PROJECT
11767 Horrobin Farm, Turton

QUESTIONS FOR THE ENGINEER

Structural queries on the ICF approval drawings - sheet 1 of 1

STATUS	DRAWING No.	REV
FOR APPROVAL	UKPCS-002-EQ-01	P01

EQ-01 CW13 marked L-18 (precast block lintel) on an ICF opening

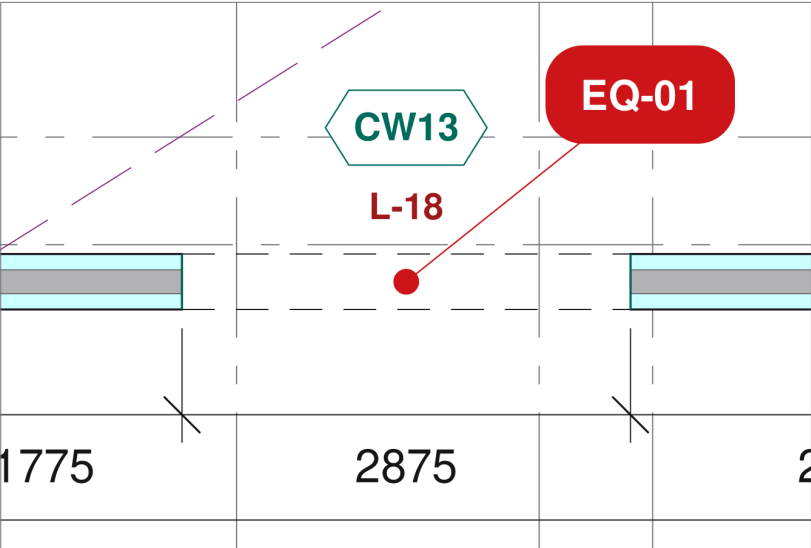
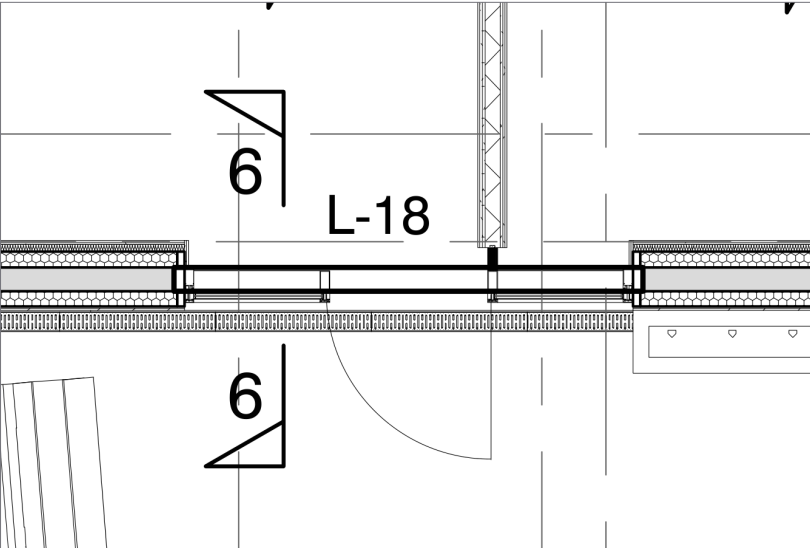
ISSUE CW13 (2875 wide, head +2400) is an opening in the external 150mm-core ICF wall. It is marked L-18, which the lintel schedule gives as a Naylor precast lintel R8 (140x215) / R7 (215x145) for 140/215 blockwork. The matching opening CW14 in the same wall is L-10 (300x150 RC, 2-H12 top / 2-H16 bott.).

QUESTION Please confirm the lintel for CW13: is L-18 intended, or should it be an RC lintel cast in the ICF core (e.g. as L-10)?

Section at D1 (model)

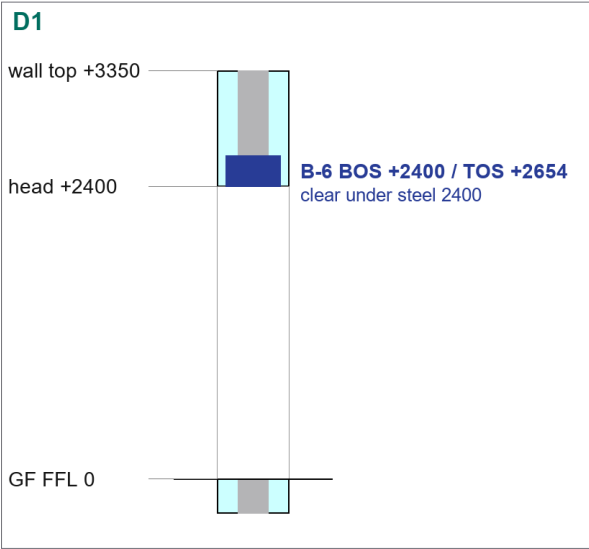
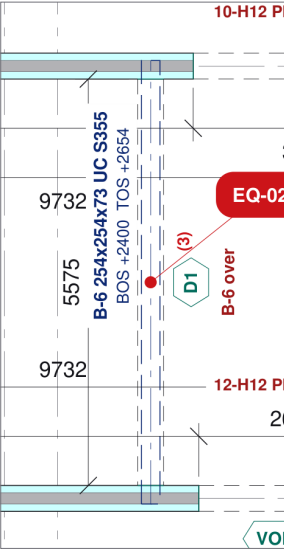
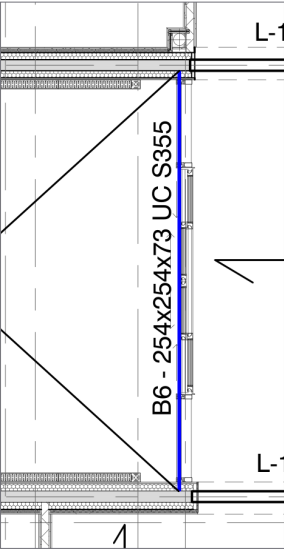
ISSUE D1 is the 5575 wide full-length opening in the ICF wall between the conservatory and the room to its east (Wall 21). Your drawing gives it no lintel mark and shows B-6 254x254x73 UC S355 (with 200x100x10 ledger angle one side) along that line. We have modelled B-6 at BOS +2400 / TOS +2654 as the head of the opening, with the structural opening in the ICF up to +2654 and ICF over the steel to the wall top at +3350, giving 2400 clear under the steel.

QUESTION Please confirm that B-6 forms the head of D1 as described (clear opening 2400 under B-6, ICF bearing on the steel above), or advise the intended arrangement.
